FILE NUMBER: 18-DP-22

SUBJECT: Site Plan Review for a 20 unit residential development (Roosevelt Apartments).

APPLICANTS MUST ADDRESS ALL COMMENTS AND FINDINGS AS IDENTIFIED BY MEMBERS OF THE TECHNICAL ADVISORY COMMITTEE BOTH IN WRITING (IDENTIFY PAGE NUMBER OF THE CORRECTION) AND ON THE SITE PLAN (ALL CHANGES MUST BE IDENTIFIED, I.E. BUBBLED).

PROPOSED 20 UNIT MULTI-FAMILY DEVELOPMENT FOR:
 XLT INVESTMENT CORP.
 16450 NE 35 AVE.
 NORTH MIAMI BEACH, FLORIDA.

6 PROPOSED SITE PLAN

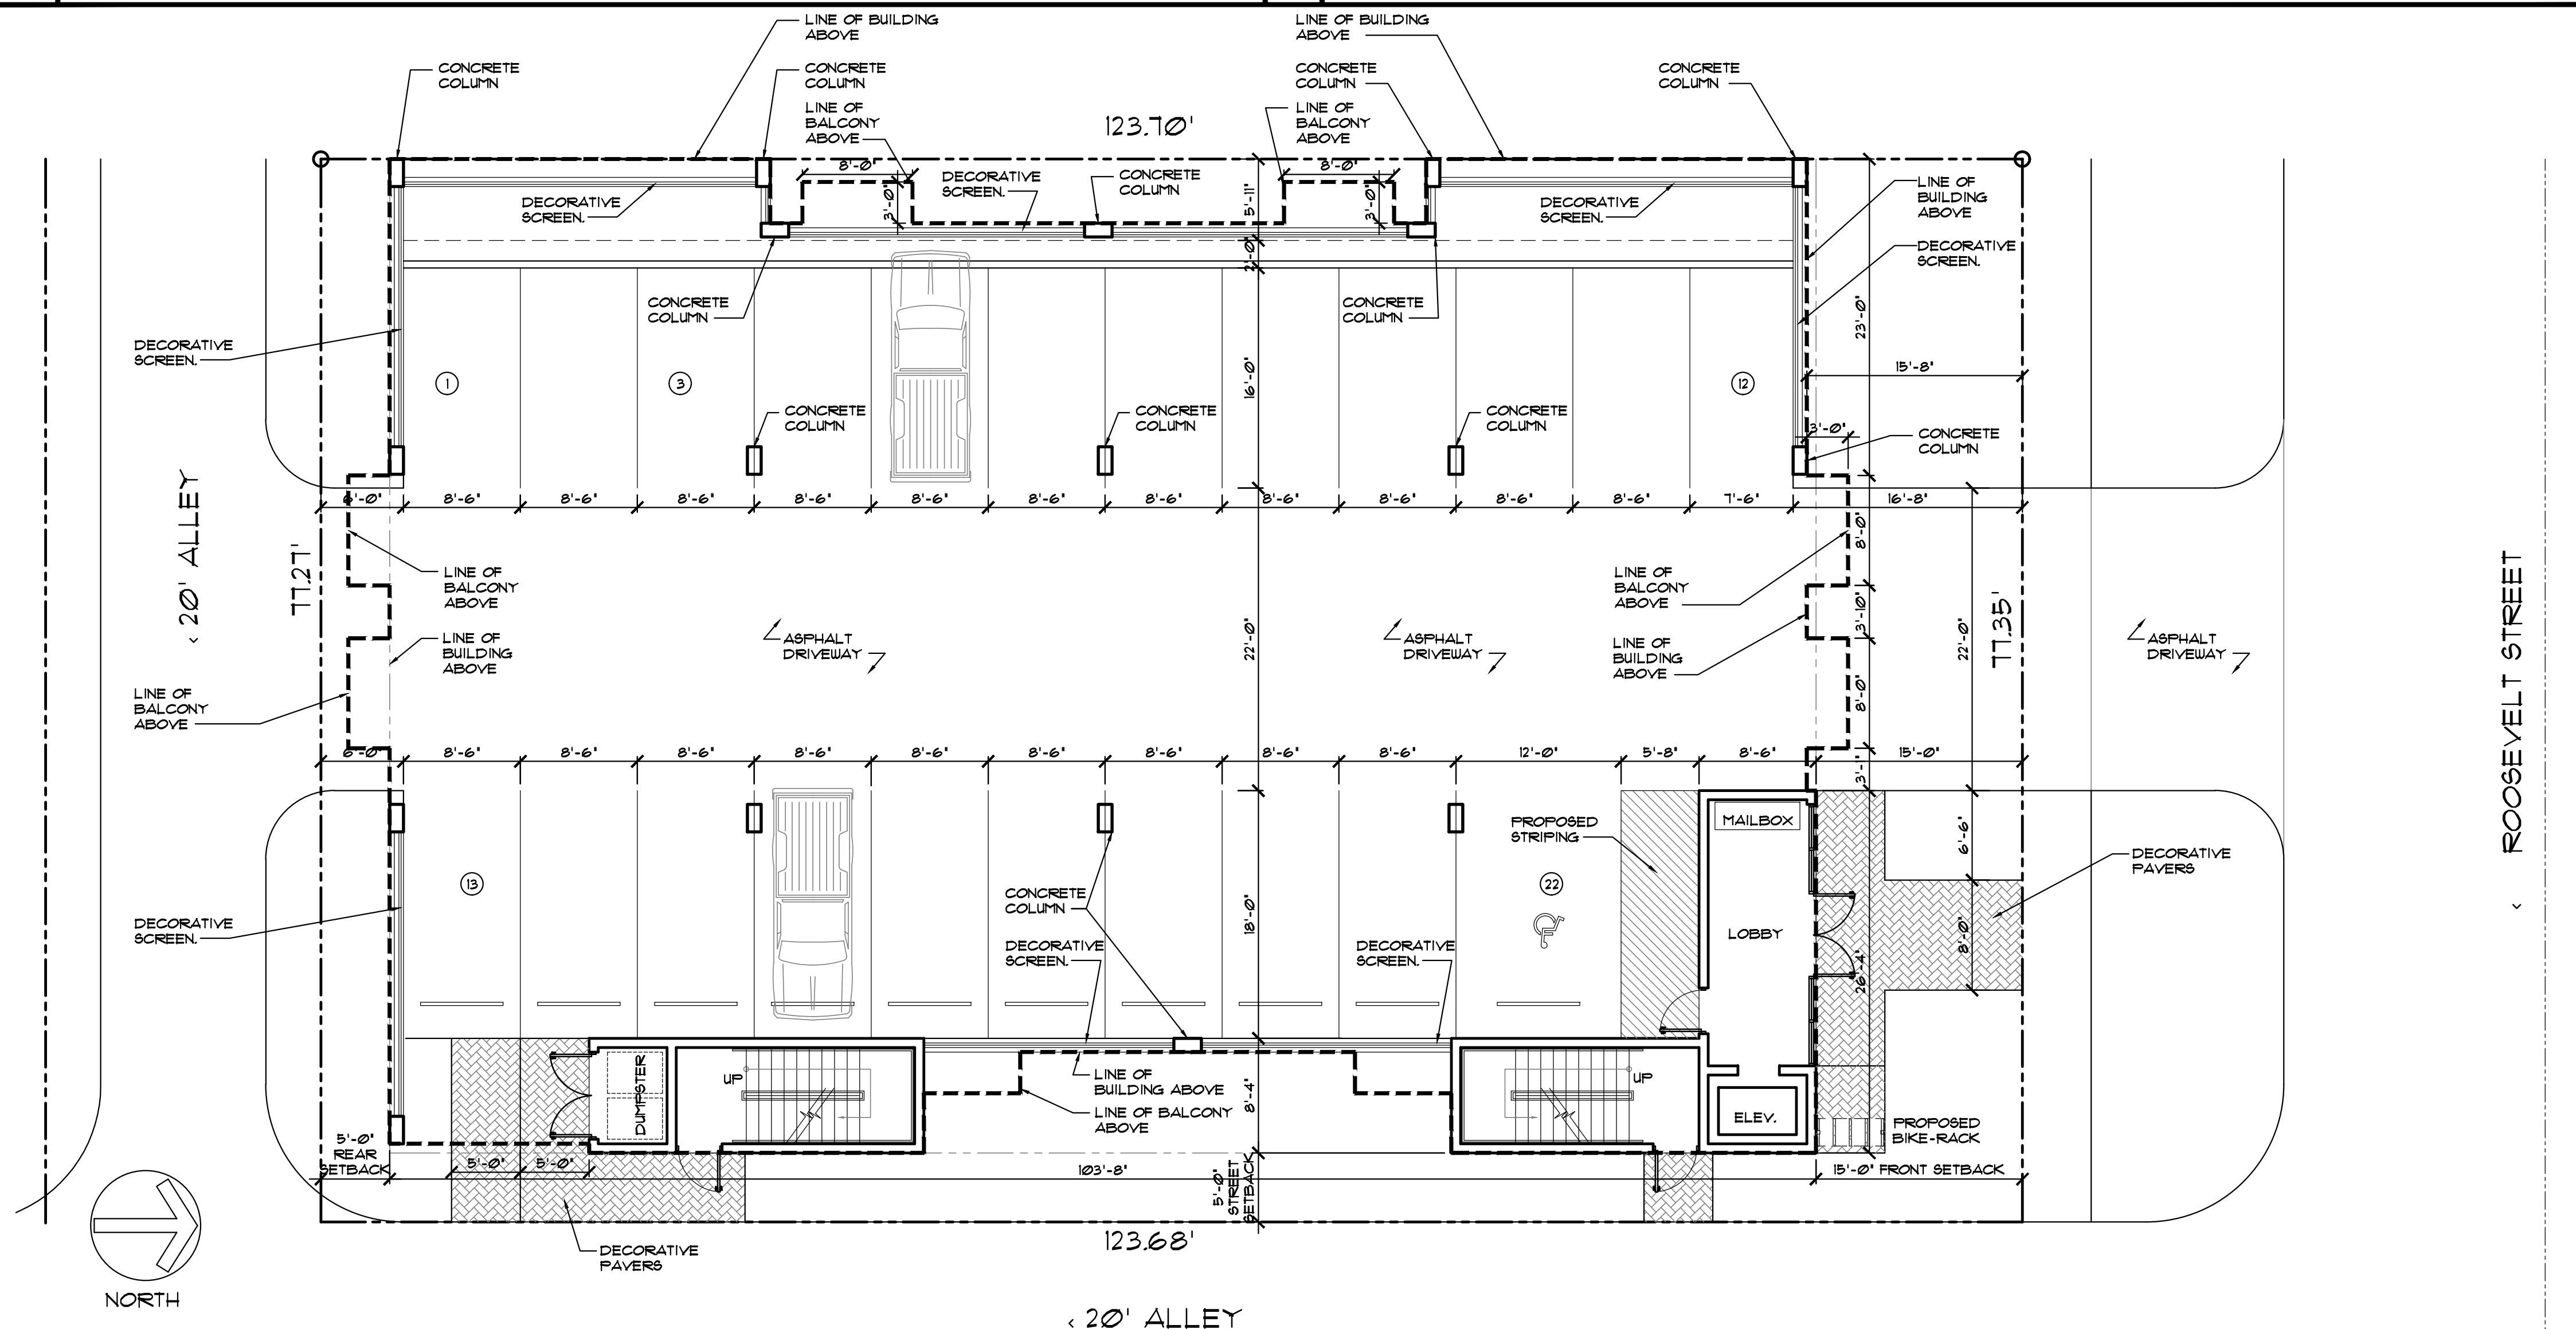
3. Provide Balcony setback dimensions on Site Plan.

4. On site calculation table, revise the required setback to 5' not 0'.

2. Sheet SP-1.1: Is there paving material under the bike rack?

4. The minimum required width of parking spaces which are adjacent to a wall or physical obstruction on one side shall be 9.5 ft.

5. It appears curbing is being proposed along the driveway opening. Provide curb ramp with detectable warning at sidewalk as necessary.

Response: Revised, refer to sheet SP-1.1

Response: Refer to note on sheet SP-1.1

Response: Refer to Sheet SP-1.1 extended pavers

Response: Revised, refer to sheet SP-1.1

Response: Refer to Sheet SP-1.1

1 PROPOSED TYP. FLOOR PLAN (2ND. & 3RD)
SCALE: 1/4"=1'-0"

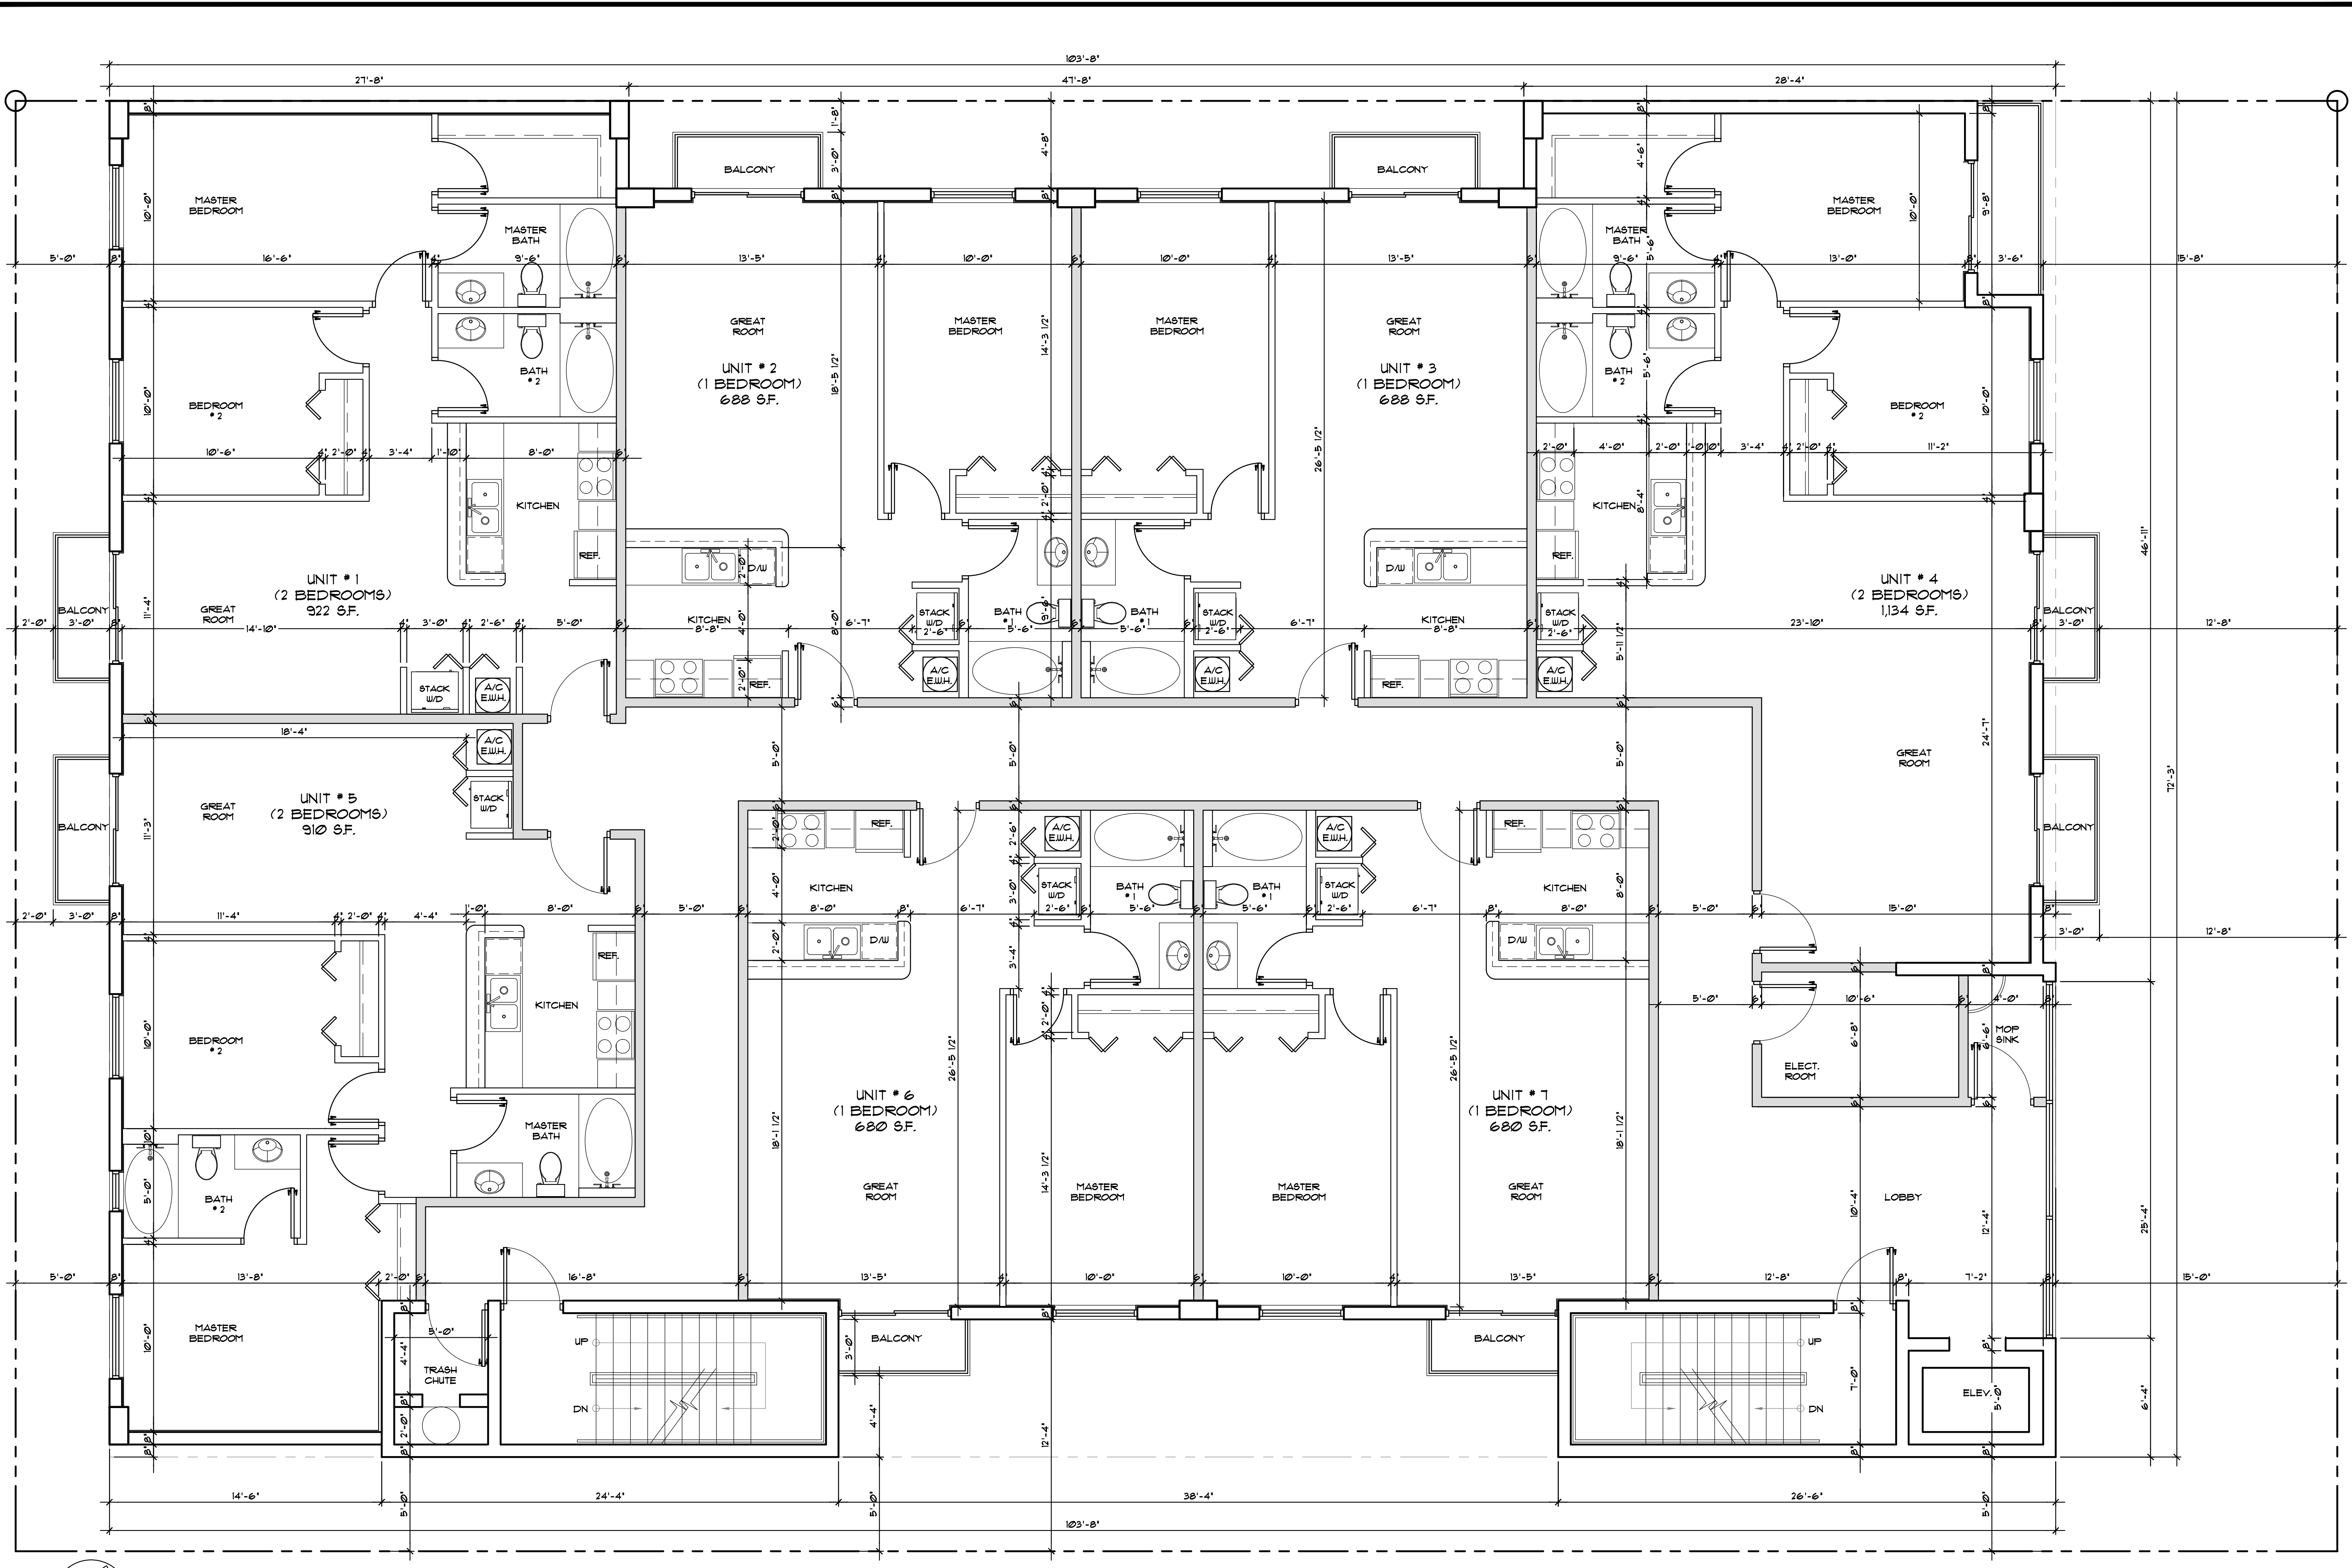
3. I don't see anything in the floor plans to accommodate a Janitor's Closet and mop sink. Where are cleaning supplies stored?

4. Sheet A-1.2 & A-1.3 – what is the purpose of the doorway from the great room of unit #4 into the common hall?

Response: Refer to Sheet A-1.2 and A-1.3

Response: Removed

A-2.1

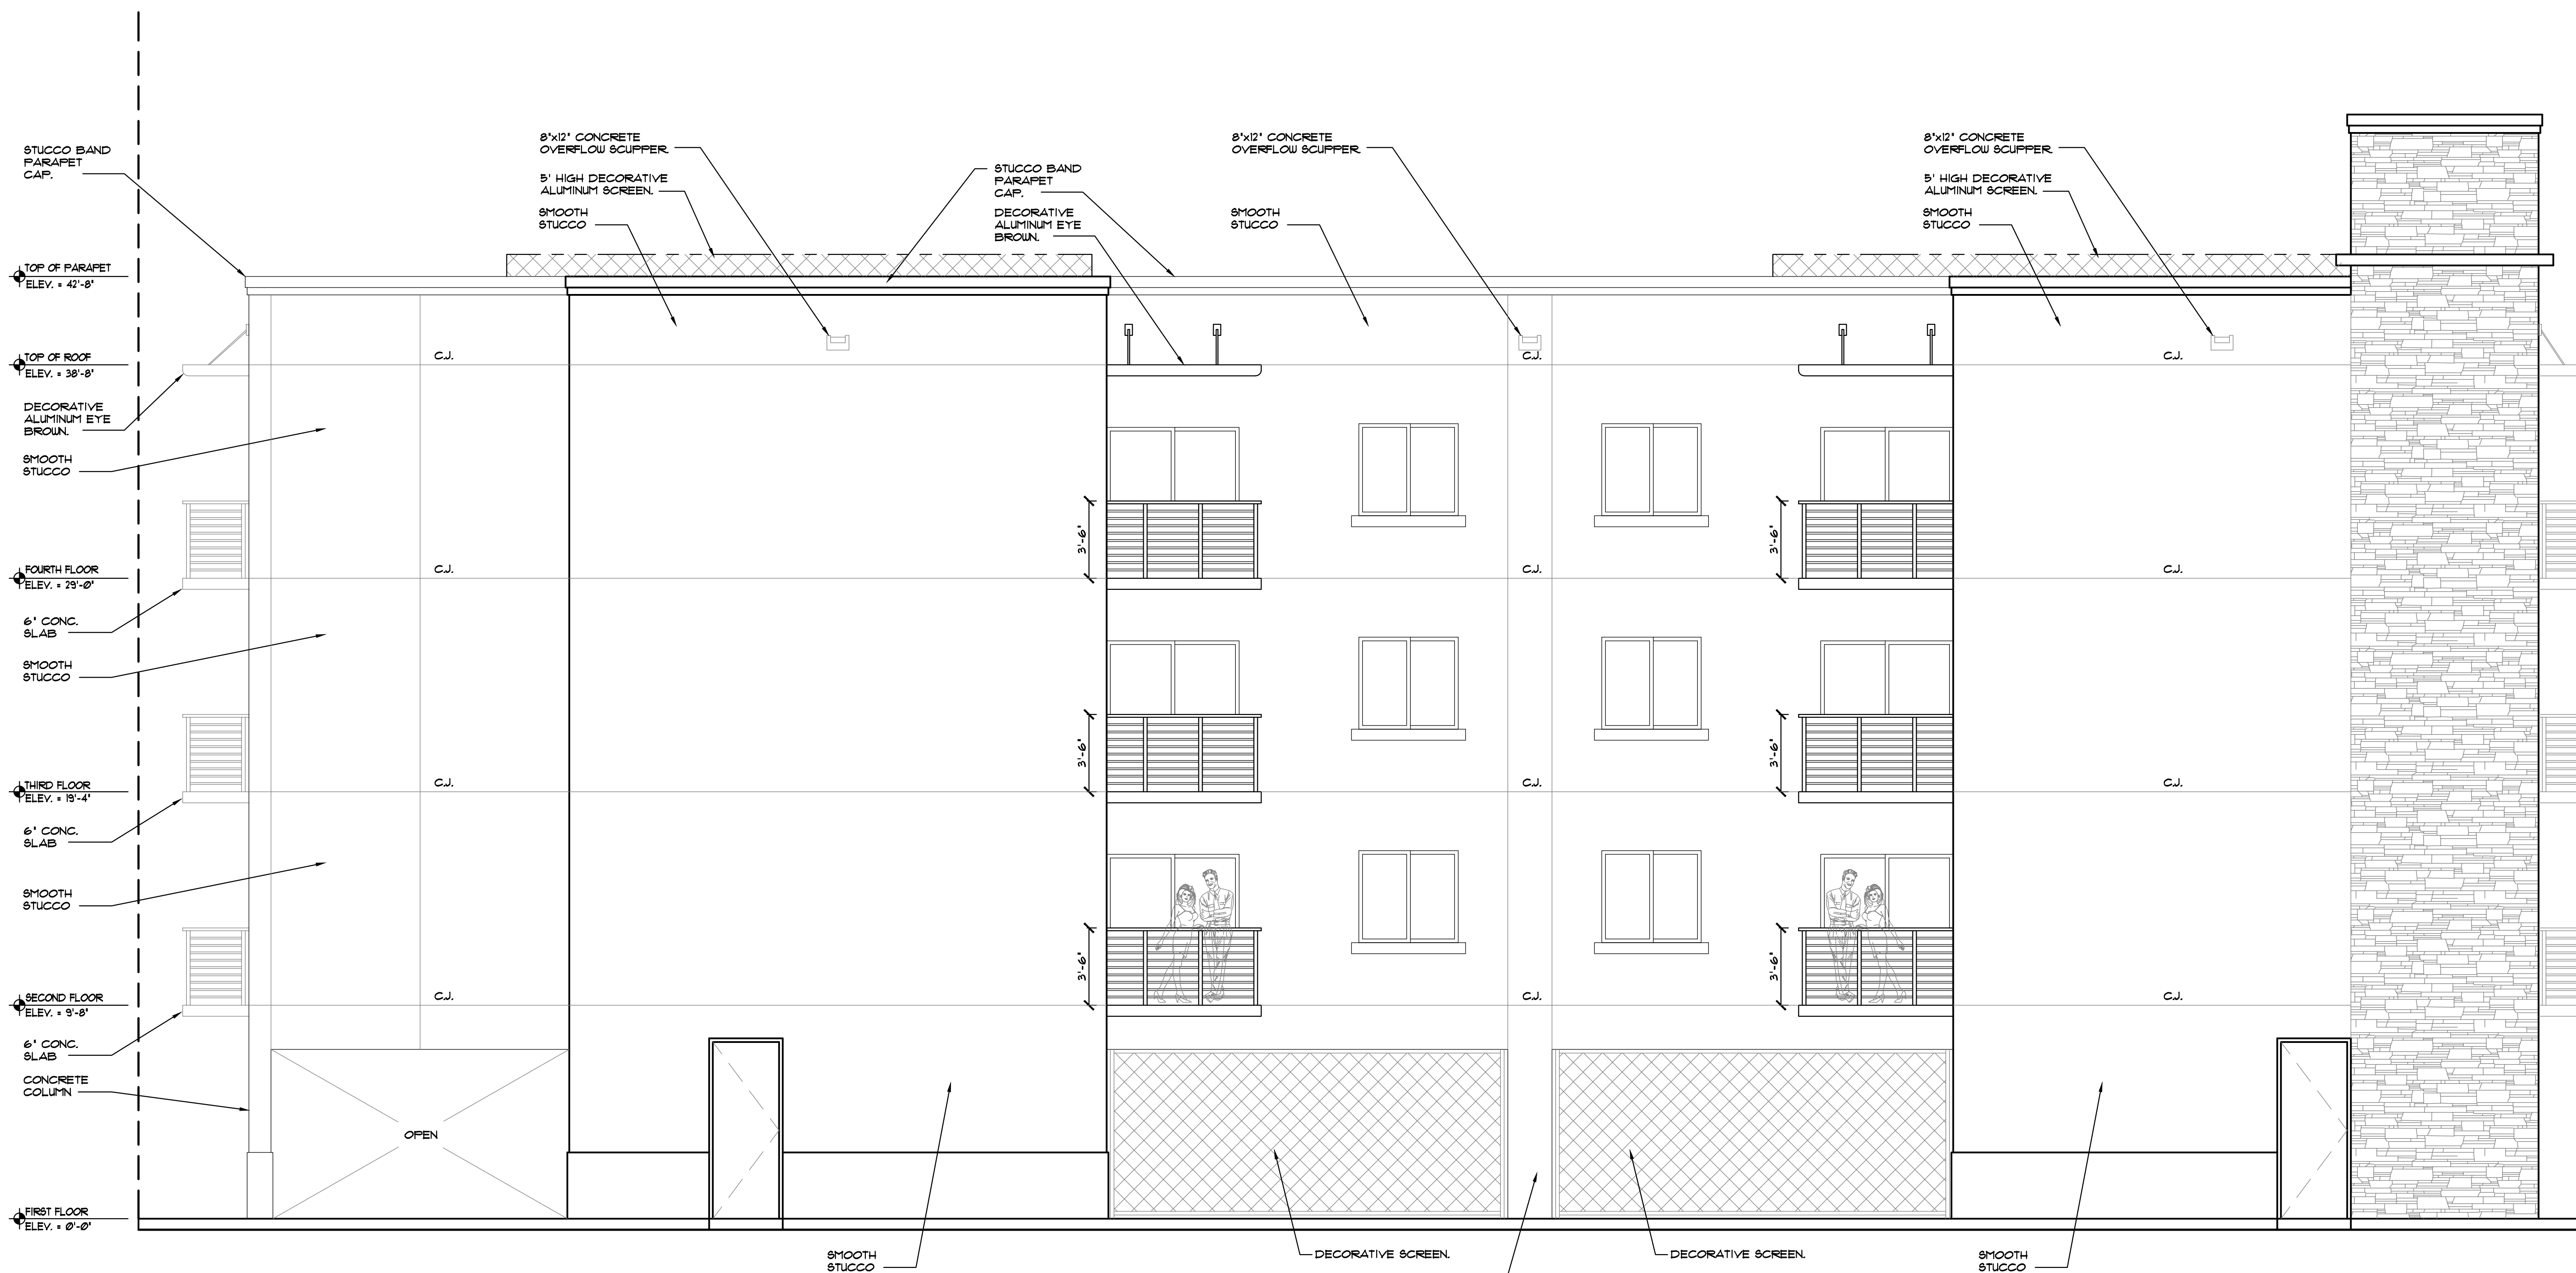
5. Sheet A-2.1 – Recommend a treatment on the stucco wall to break up the plane.

Response: Provided
